**Wyoming Department of Environmental Quality  
Land Quality Division  
Uranium Recovery Program**

**STATE DECISION DOCUMENT  
TECHNICAL REVIEW OF ANADARKO BEAR CREEK URANIUM COMPANY MILL  
SITE'S REQUEST TO ABANDON ALL MONITORING WELLS**

**PERMITTING REQUEST**

By letter dated April 24<sup>th</sup>, 2019, Anadarko submitted a request to the Wyoming Department of Environmental Quality Land Quality Divisions (LQD) to abandon all monitoring wells located at the site in anticipation of the site transferring to the Department of Energy (DOE) for long-term maintenance.

Figure 2 Well Locations (DOE 2016)

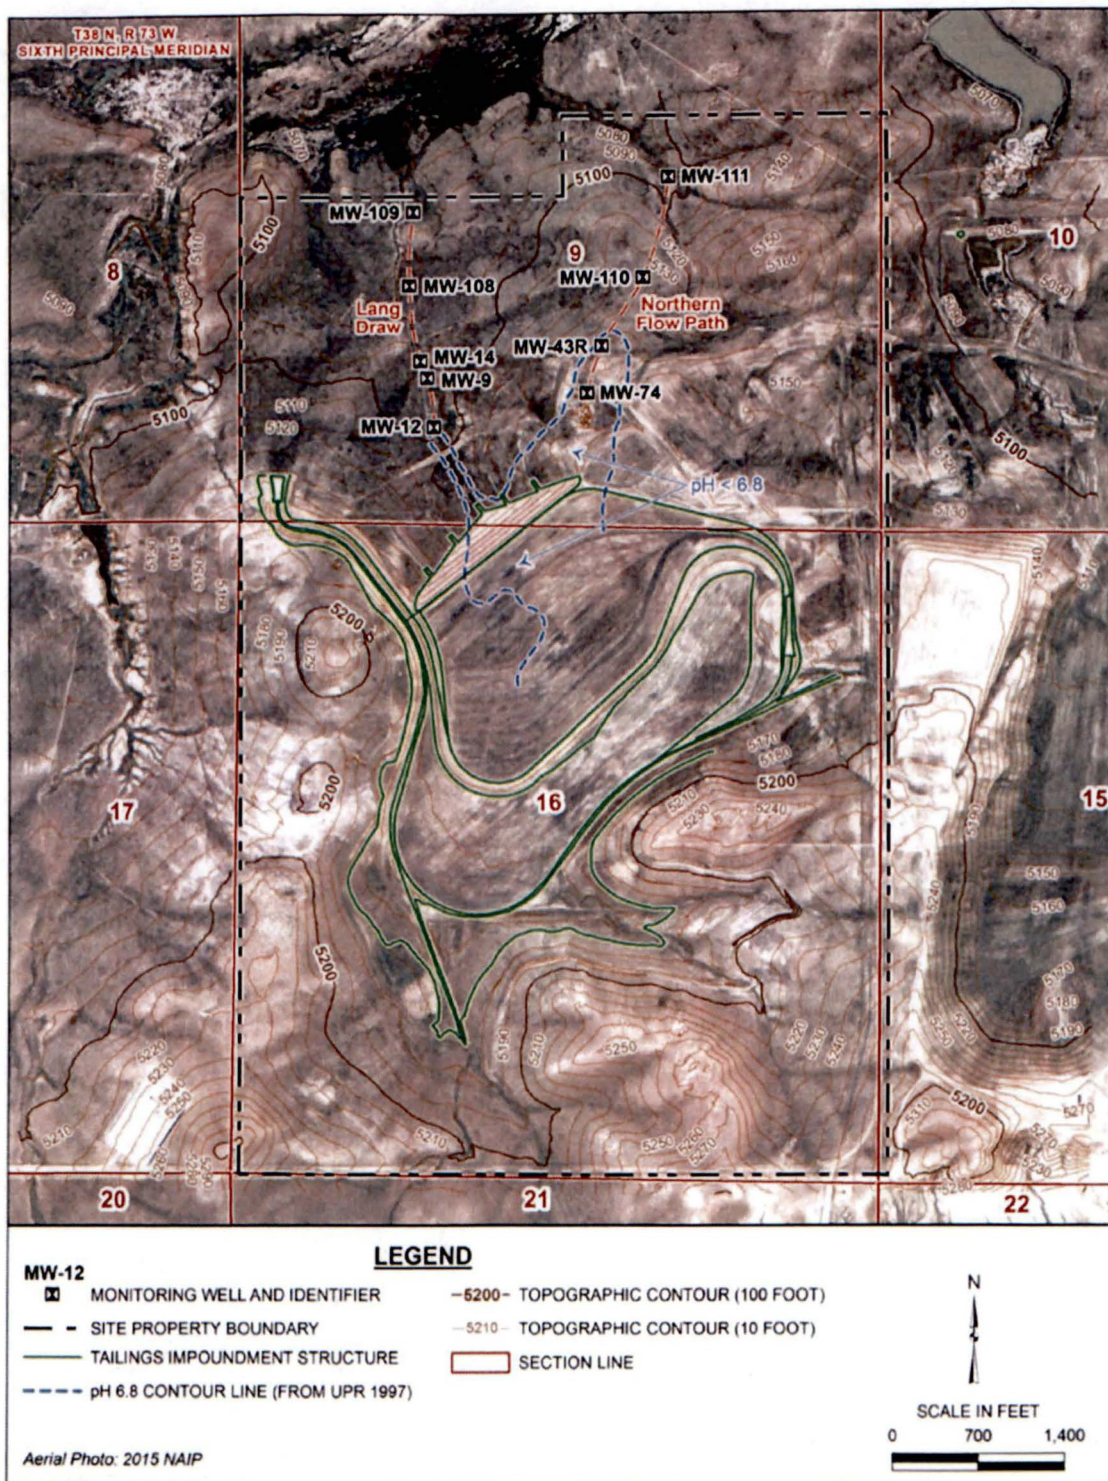
The N Sand in the site area is not hydraulically connected to a usable aquifer or any surface water resource. The alluvium in the vicinity of the site does not contain appreciable water and has been determined to not be a viable aquifer (Stoller 1997). Estimated yields for wells MW-108 and MW-109 (Figure 2) at the northern edge of the boundary are 0.01 gallons per minute (UPR 1997). Significant groundwater was not encountered in any of the boreholes along the Lang Draw during the 1997 drilling effort. NRC concluded that there was no viable aquifer at the site (NRC 2013). No groundwater seeps have been noted in Lang Draw from discharge of either the N Sand or alluvium by DOE or contractor personnel during site visits.

**Figure 4 Predicted vs Measured Uranium Concentrations Along the Lang Draw Flow Path (NRC 2013)**

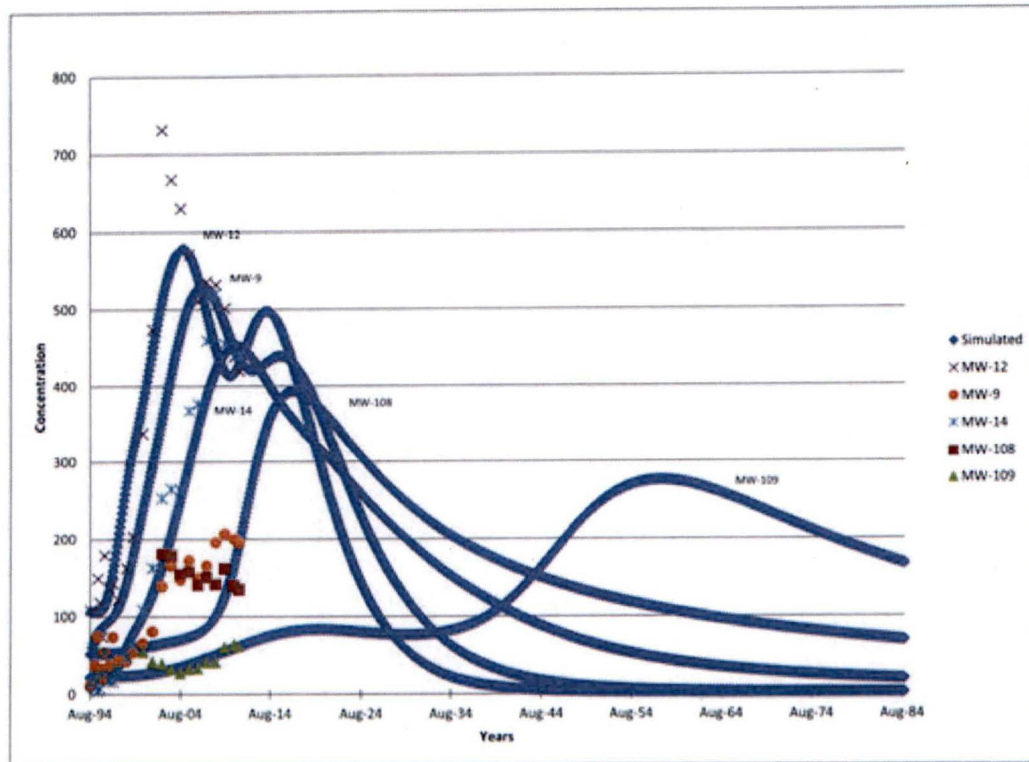
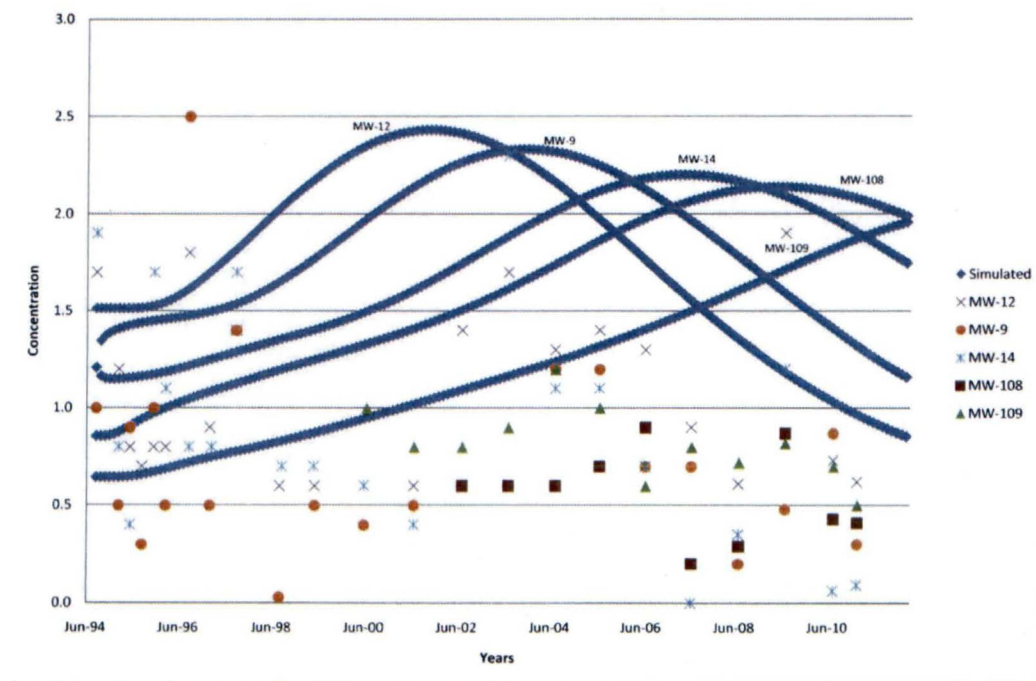
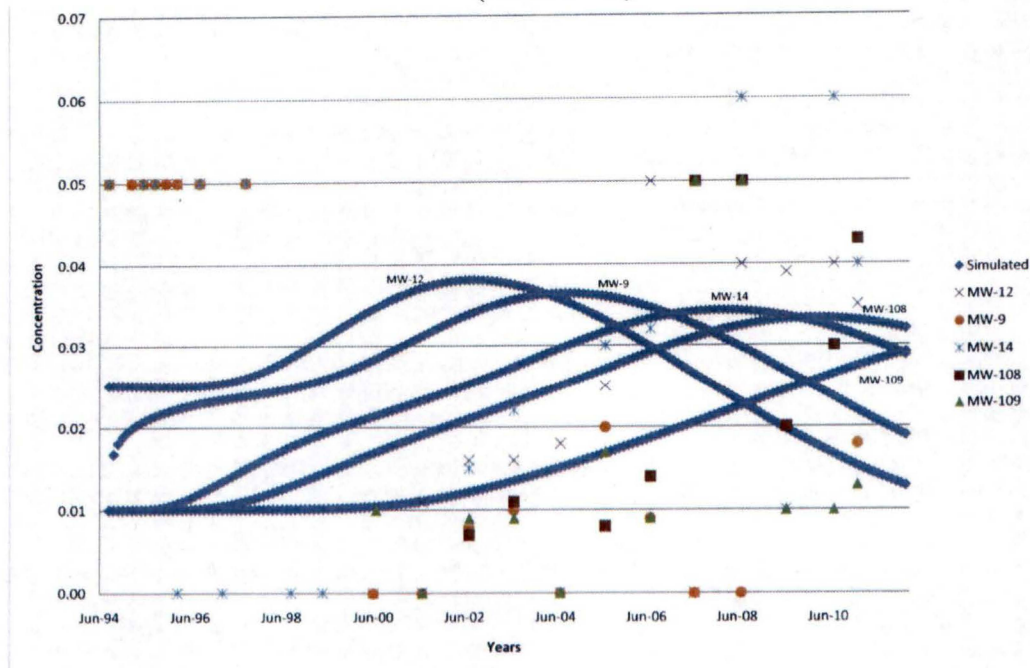
In the evaluation of the ACL for the Bear Creek Site the NRC determined the estimated level of risk using the projected concentrations of uranium, combined radium, and nickel at the POE well MW-109 is on the order of  $10^{-4}$ , similar to the background risk for the site. Additionally the ACL for the Site meet the requirements of 10 CFR 40 Appendix A Criterion 5B(6). Figures 4-7 show the predicted concentrations of Uranium, Radium, and nickel at the POE well.

The water quality data from 2002 through 2012 at the POE show that the measured values are lower than the predicted values. The data is tabulated in Attachment 2.

Based on the current and historic use of the N and K Sands, the quantity of groundwater in the N and K Sands, the classification of the N and K Sands as industrial up to 160 ft for Section 16 and 9 for Township 38 N. Range 73 W. , and the modeled results compared to actual observed data the LQD concurs with the NRC decision that no groundwater monitoring is necessary since the only viable aquifer is greater than 400 feet below the surface, and there is no connection with the mill tailings. As was instructed with the NRC letter dated February 15, 2015 the remaining monitoring wells should be capped and abandoned in accordance with Water Quality Regulations concerning well abandonment.
